**47 Lauder Road EH9 1UE**  
**Planning Application 21/05410/FUL**  
**OBJECTION from Grange Association**  
**12 November 2021**

This application is for an L-shaped ‘garden studio room’ in the grounds of this B-listed villa. There are a number of recent examples of garden rooms being approved for development in rear gardens in the Grange. However, this proposal is exceptional in its scale, height and form and we request that it be refused. Our objections concern:

Proposed site plan

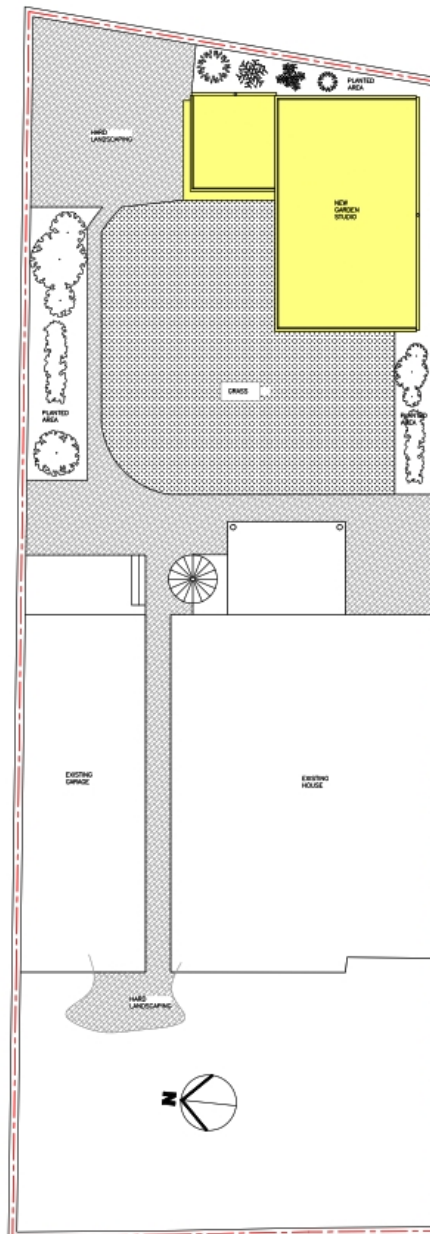
The proposal is for a studio room of two elements which together would have a footprint of 53m<sup>2</sup>, which is 8% of the total plot and 37% the size of the original villa. This would increase the amount of the site covered by buildings, garages and access driveways to 48%, greater than the 40% maximum specified in the [Householder Guidance](#) (page 10) for villas.

Additional hard landscaping is proposed that will increase the proportion of the site coverage to 66%, leaving only one third of the site available for gardens.

However, the proposals would breach all of the final three guidelines above: with the garden studio, the total site coverage of new and existing buildings would be 1.85 times the original villa; the site coverage of all buildings, garages and access driveways would be 48% of the site area; the rear façade of the studio room would be just 0.6m from the rear boundary wall.

Proposed East elevation

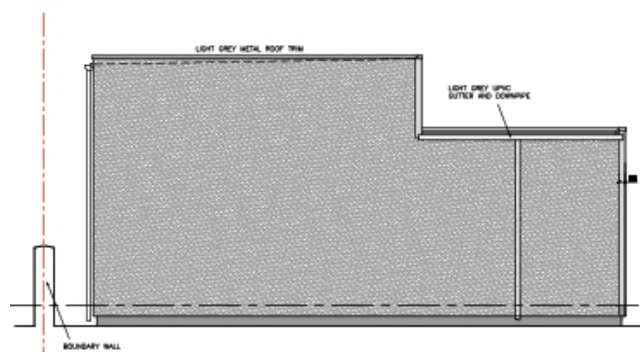
47 Lauder Road backs onto the west side boundary of 4 Hatton Place. The proposed location for the studio room would obscure the only section of the west boundary of 4 Hatton Place that is garden space. The proposed height of the new room, at 4.14m is excessive and would shade the neighbour's garden, casting shadow with the evening sun.

The applicant has provided no supporting statement to explain why this proposed garden studio needs to be so abnormally high. As the applicant's East elevation drawing shows (reproduced above) the studio would tower above the existing boundary wall, presenting an unrelenting expanse of cement render to the neighbours.

Householder Guidance (page 13)

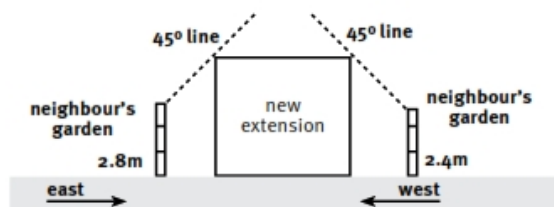
The [Householder Guidance](#) (page 13) specifies the minimum sunlight that must be protected for existing developments. It includes the simple 45-degree method, which specifies that sunlight from the west should be available at a 45° angle from a line 2.4m above the ground. The proposed development, with a 4.1m building just 0.6m from the wall, fails this test.
